**Subject:** RE: EA comments on flood compensation for undercrofts - Planning Application 16/00472/OUT - Grundon Waste

**Subject:** EA comments on flood compensation for undercrofts - Planning Application 16/00472/OUT - Grundon Waste

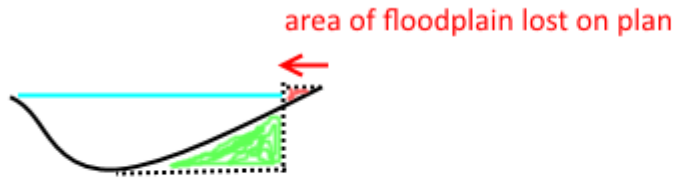
Your volume calculations are basic as you are assuming an even depth of flooding (0.2 m) at each band. However in reality the ground levels at each band are not set to a flat level of 89.75, 89.95 and 90.15 m but, as natural ground levels, they will have varying depths of flooding at each level. Your volume estimates assume a prismatic volume which would over estimate the total volume at each band in the baseline and post development schemes.

Hopefully this figure explains this;

dashed line is proposed excavated area/platform

green is volume of flood storage gained

the red area is some of the floodplain storage lost (less than what was gained)

The green area in the sketch figure would therefore be a gain in flood volume despite the flood extent area being reduced.
